preliminary overall area development plan

WOODLAKE PARKWAY
205.729 acre tract

Re: Woodlake Parkway Preliminary Plan
 P.O.A.D.P.

File #: 85-20-60-22 revised May 22, 1985

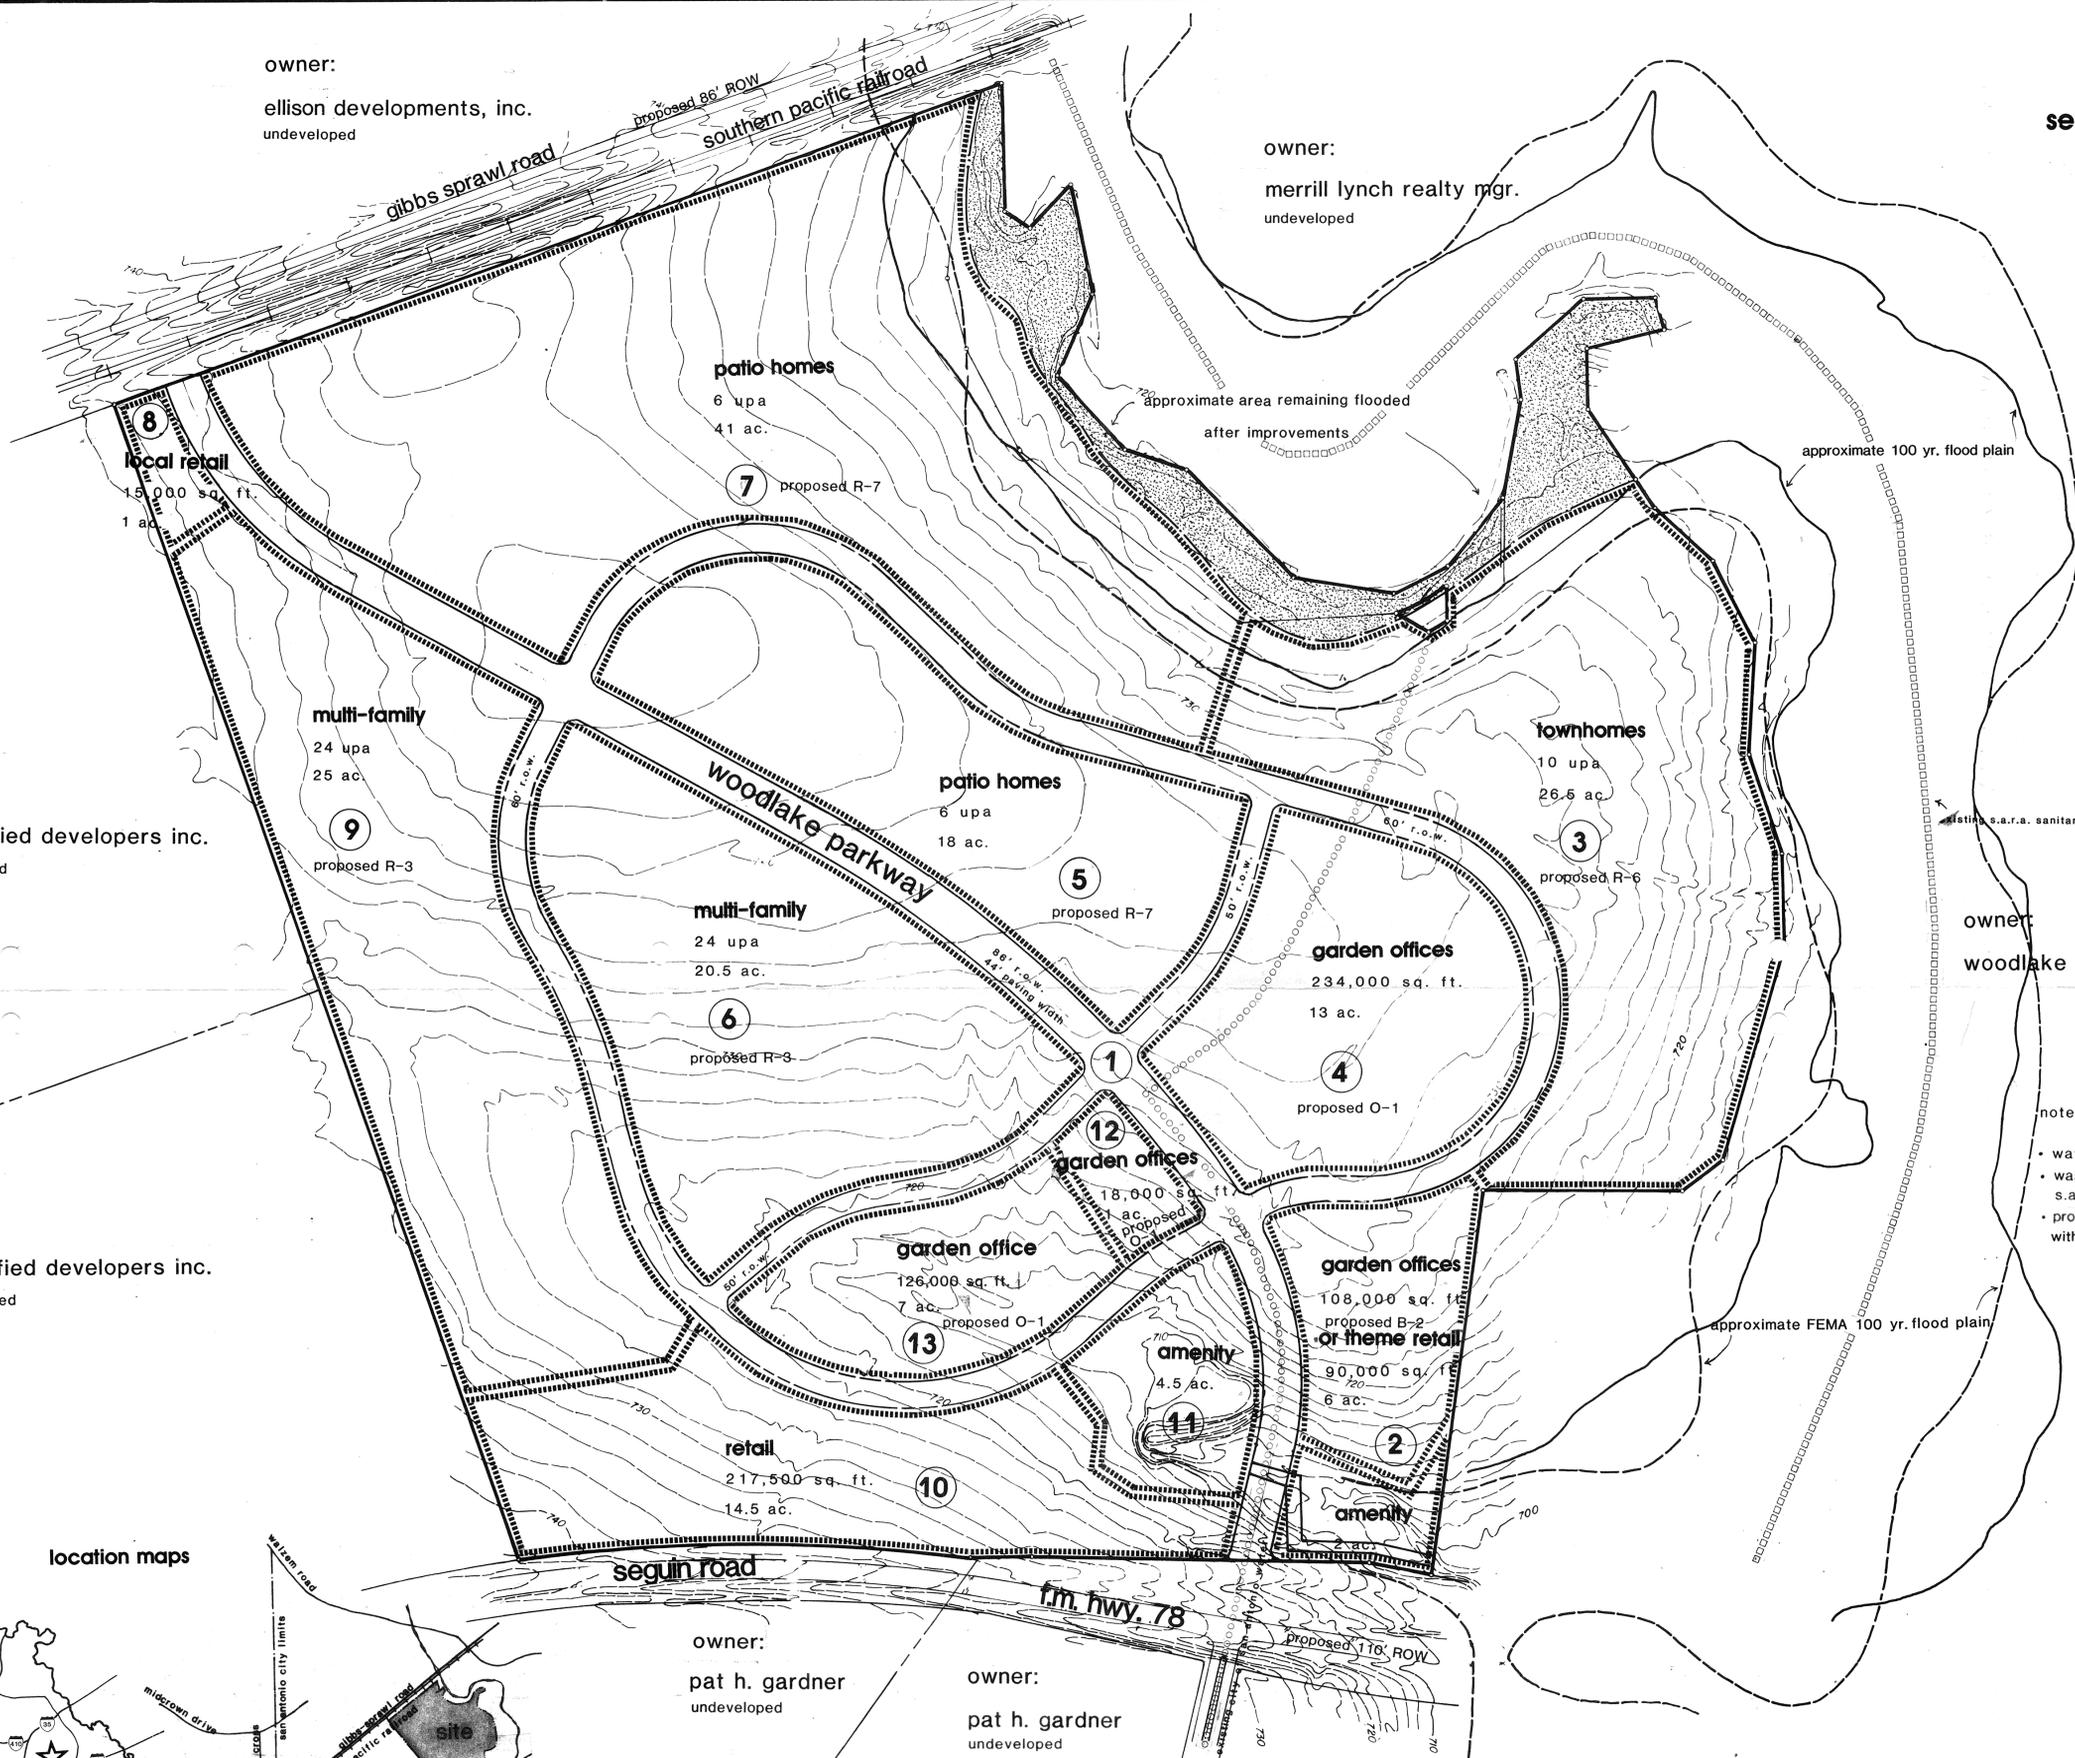
Comments: Because of the development activity that is occurring in the immediate area, it will be necessary for you to coordinate the alignment of Woodlake Parkway with the Ray Ellison property to the north for proper alignment of said thoroughfare. Thank you.

(X) Comments: The P.O.A.D.P. committee has reviewed your proposed plan for Woodlake Parkway and is recommending that the 50' R.O.W. be upgraded to a 60' local type "B" due to the abutting commercial development.
